Service Service Service

TV-05/0150

On both Ambilight panels 3104 328 43702 & 39552, a wrong elco is stuffed on item number 2001:

2. SITUATION ON THE PWB

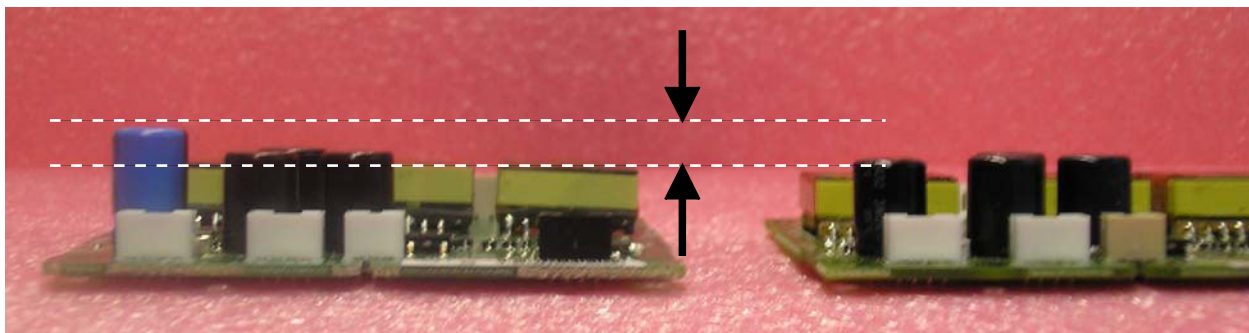
- Wrong part: Lelon type, dimensions 10x16 (DxH)
- Correct part: Rubycon type, dimensions 10x12.5 (DxH), order code 2020 012 00018

Different in height is not acceptable! This difference causes high safety problem.
